CITY OF VINELAND

**RE: Street Lighting Recommendations  
September 2017**

## STREET LIGHTING RECOMMENDATIONS

SEPTEMBER 2017

<b>PROPOSED STREET LIGHT REVISION</b> AREA OF PEACH STREET BETWEEN EAST BOULEVARD AND EAST AVENUE	
<b>VINELAND MUNICIPAL ELECTRIC UTILITY</b> <b>VINELAND, NEW JERSEY</b>	
DRAWN: CAM	VAULT # F-3-C
DATE: 8/7/2017	DRAWING # VMEU-2839
SCALE: NTS	CHECKED:

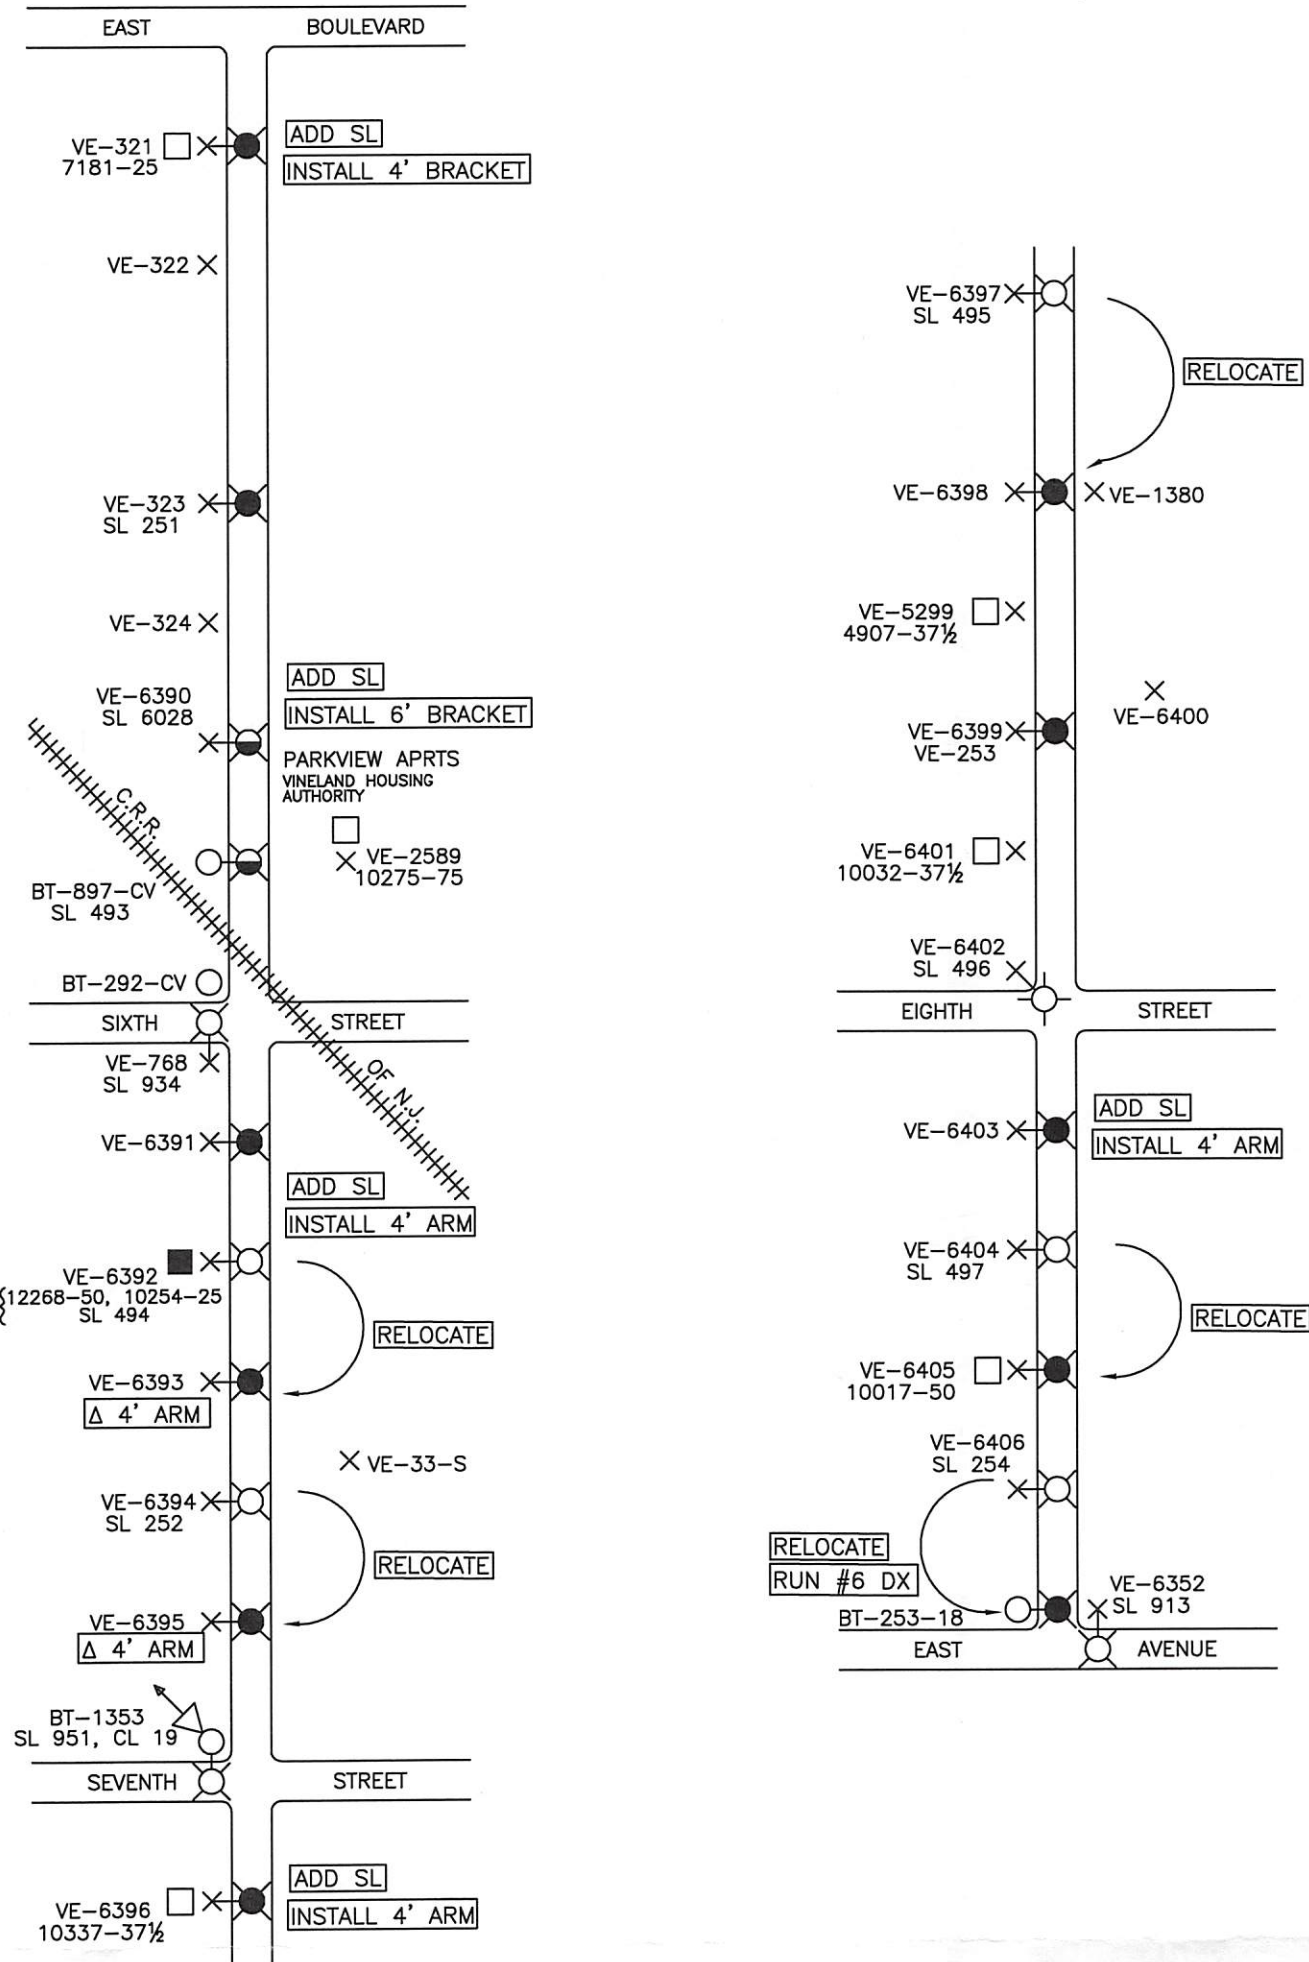
1. Area of Peach Street  
*(between East Blvd & East Avenue)*  
Drawing No. VMEU-2839  
Upgrade seven (7) existing street lights to 74W LED (relocating five), and one (1) to 108W LED. Install an additional four (4) 74W LED, and one (1) 108W LED onto existing utility poles.

**PROPOSED:** Upgrade seven (7) existing street lights to 74W LED(relocating five), and one (1) to 108W LED. Install an additional four (4) 74 W LED, and one (1) 108W LED onto existing utility poles.

<b>PROPOSED STREET LIGHT REVISION</b> AREA OF UNION RD BETWEEN CITY LIMITS AND HAWTHORN CT	
<b>VINELAND MUNICIPAL ELECTRIC UTILITY</b> <b>VINELAND, NEW JERSEY</b>	
DRAWN: CAM	VAULT # F-3-C
DATE: 8/8/2017	DRAWING # VMEU-2840
SCALE: NTS	CHECKED:

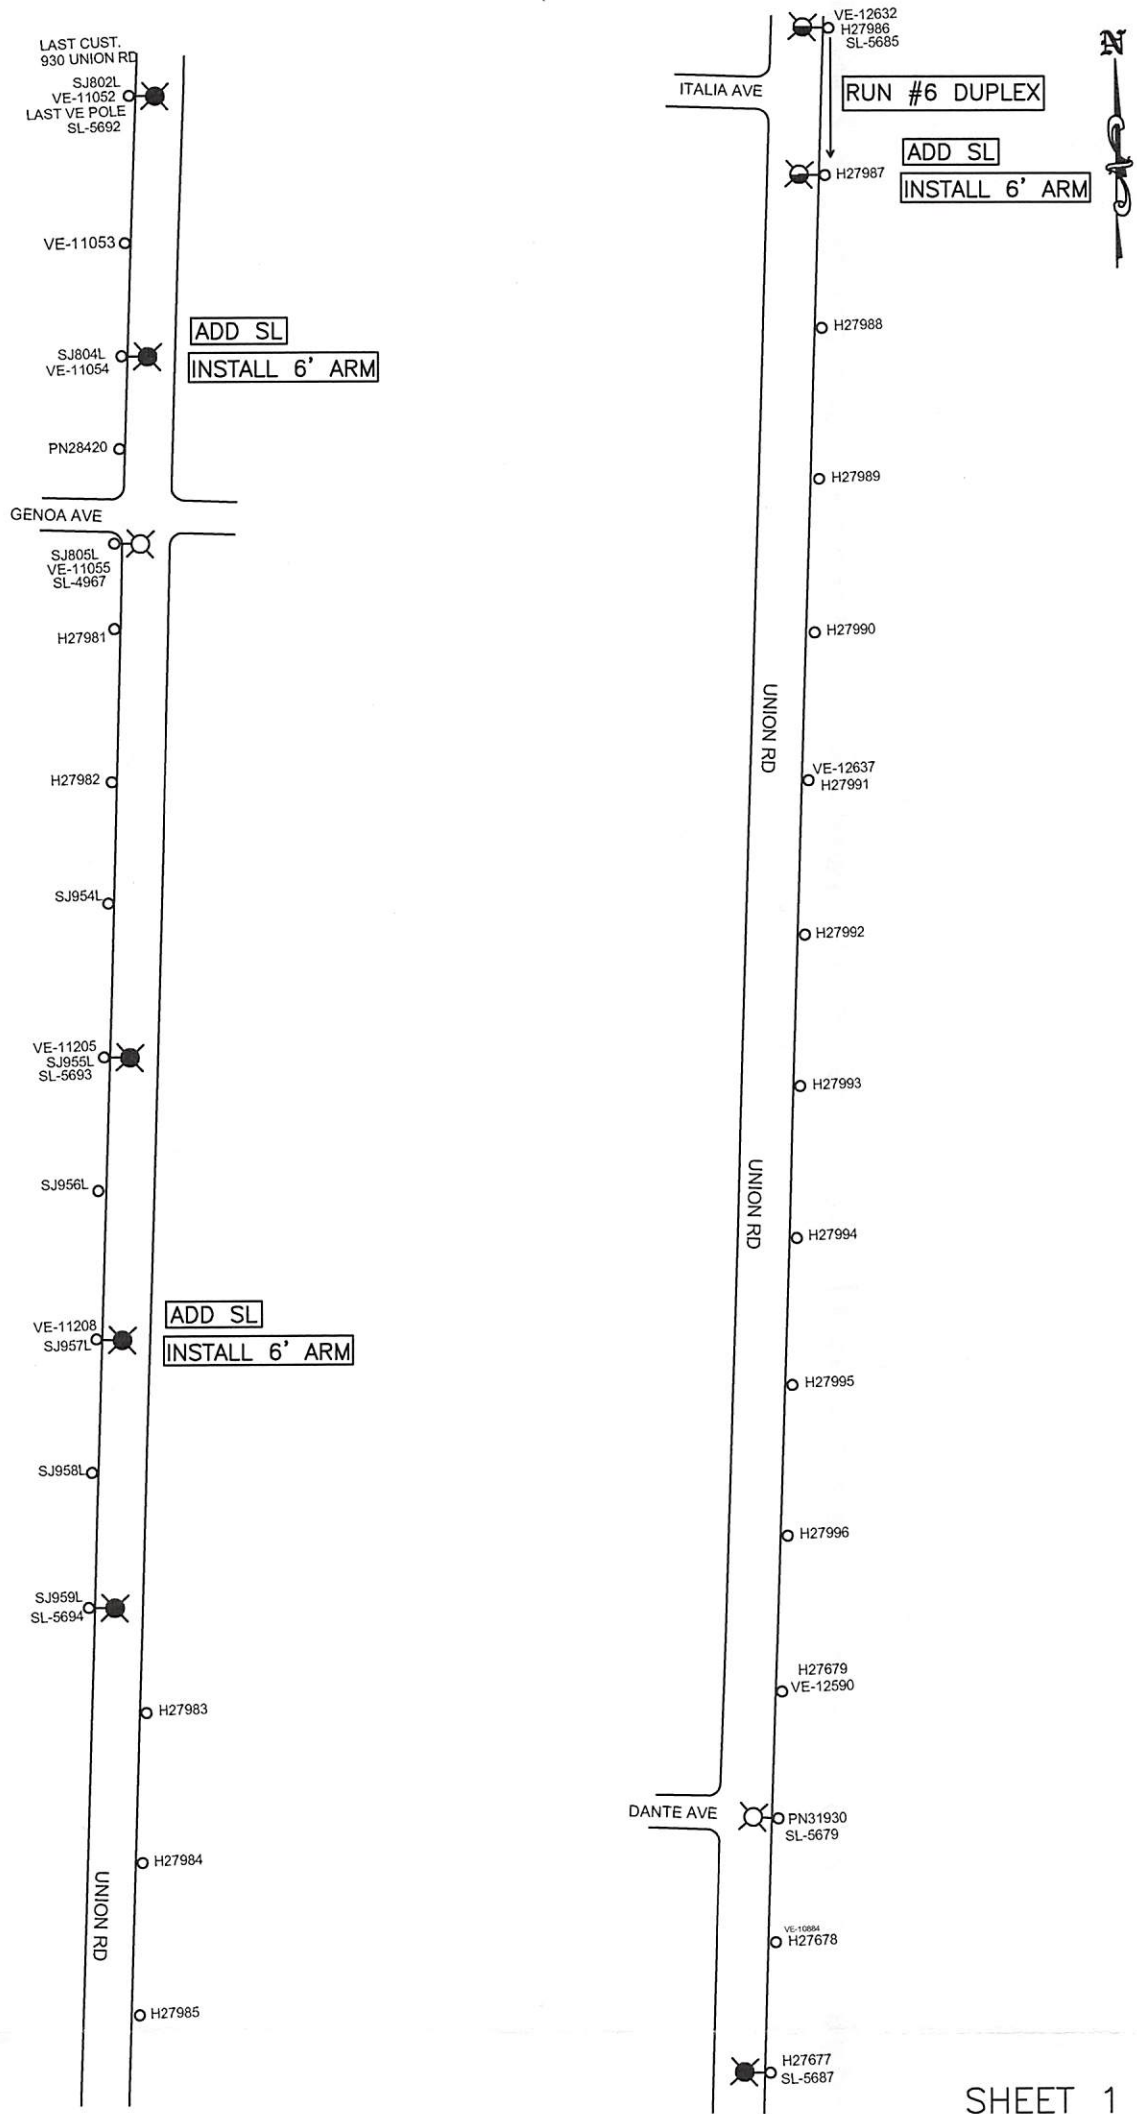
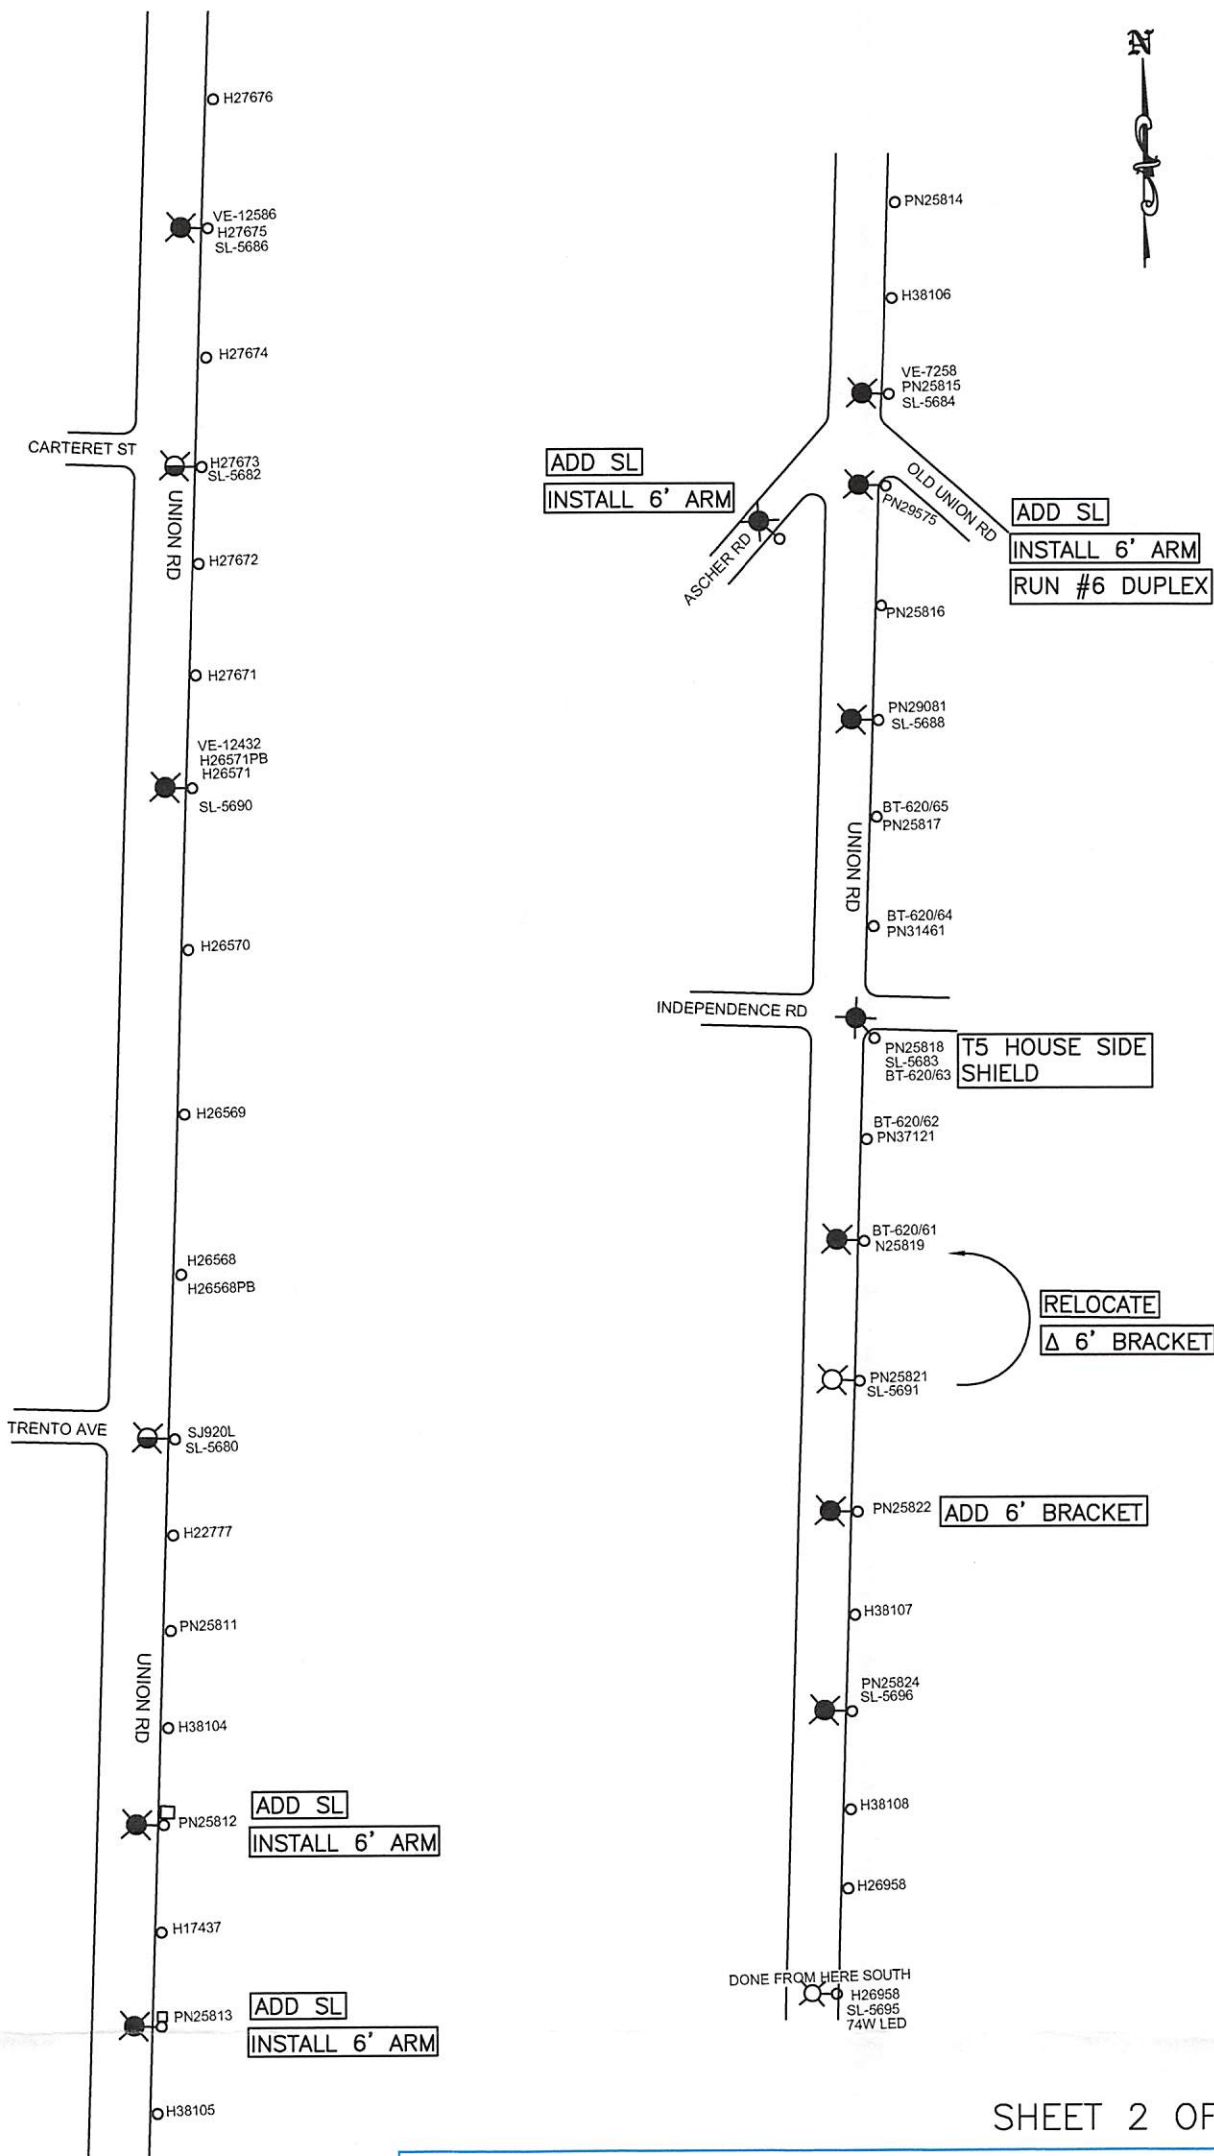
2. Area of Union Road  
*(between City Limits & Hawthorn Ct)*  
Drawing No. VMEU-2840  
Upgrade eleven (11) existing street lights to 74W LED (relocating one), and three (3) to 108W LED. Install an additional eight (8) 74W LED and one (1) 108W LED onto existing utility poles.

**PROPOSED:** Upgrade eleven (11) existing street lights to 74W LED(relocating one), and three (3) to 108W LED. Install an additional eight (8) 74W LED and one (1) 108W LED onto existing utility poles.

<b>PROPOSED STREET LIGHT REVISION</b> AREA OF BREWSTER RD BETWEEN OAK RD AND CITY LIMIT	
<b>VINELAND MUNICIPAL ELECTRIC UTILITY</b> <b>VINELAND, NEW JERSEY</b>	
DRAWN: CAM	VAULT # F-3-C
DATE: 8/9/2017	DRAWING # VMEU-2841
SCALE: NTS	CHECKED:

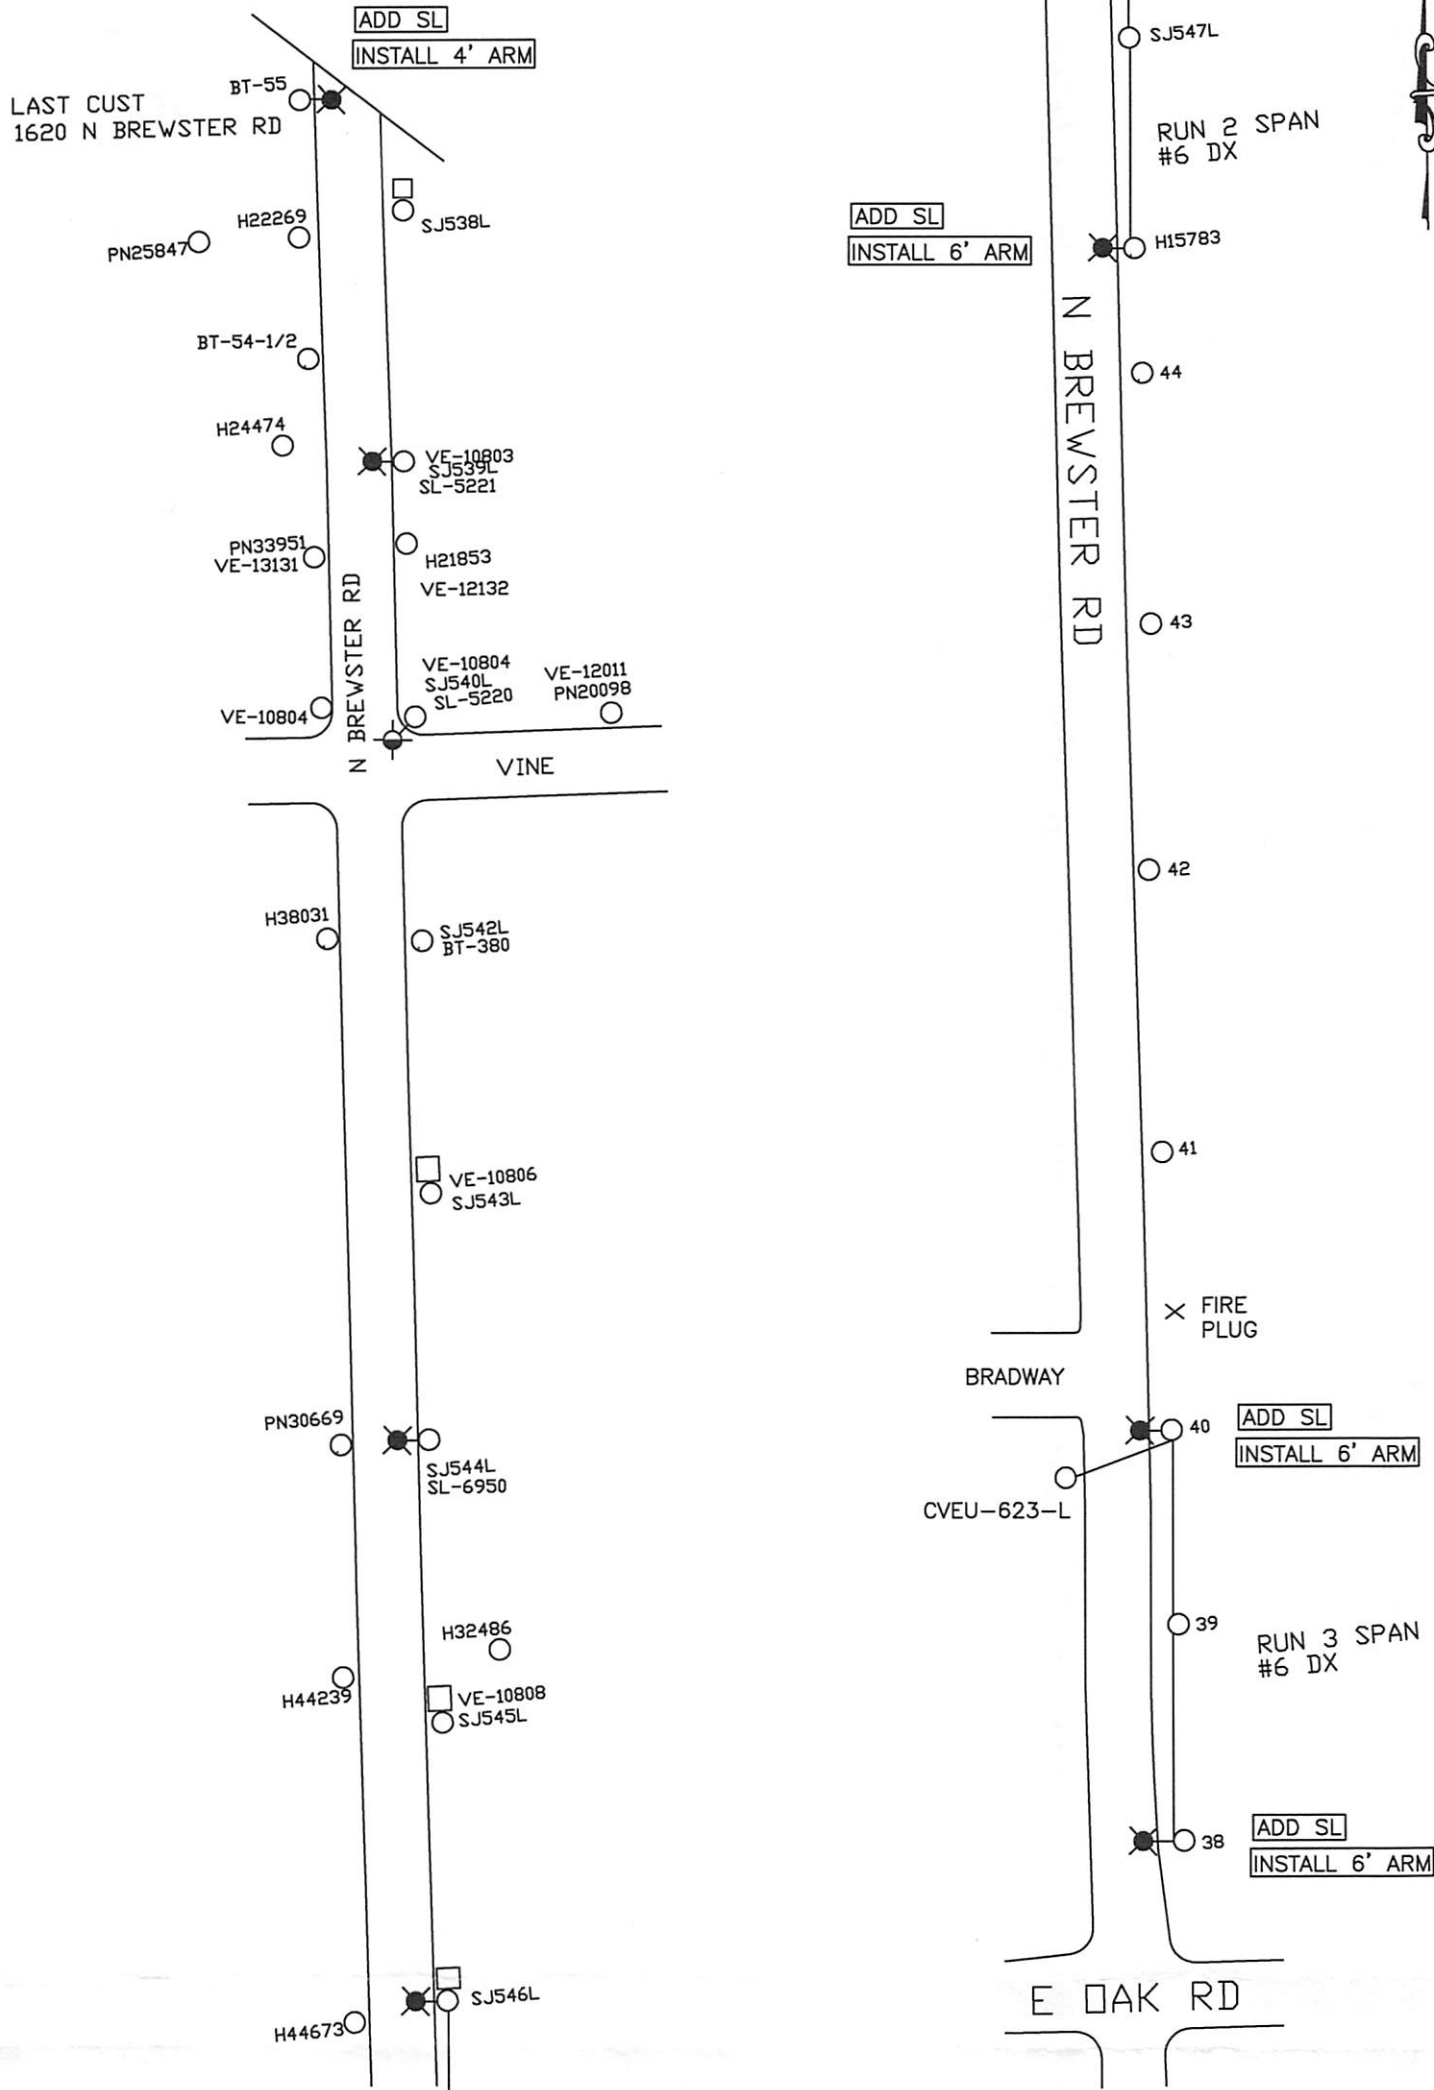
3. Area of Brewster Road  
*(between Oak Rd & City Limits)*  
Drawing No. VMEU-2841  
Upgrade three (3) existing street lights to 74W LED, and one (1) to 108W LED. Install an additional four (4) 74W LED onto existing utility poles.

**PROPOSED:** Upgrade three (3) existing street lights to 74W LED, and one (1) to 108W LED.

Install an additional four (4) 74W LED onto existing utility poles.
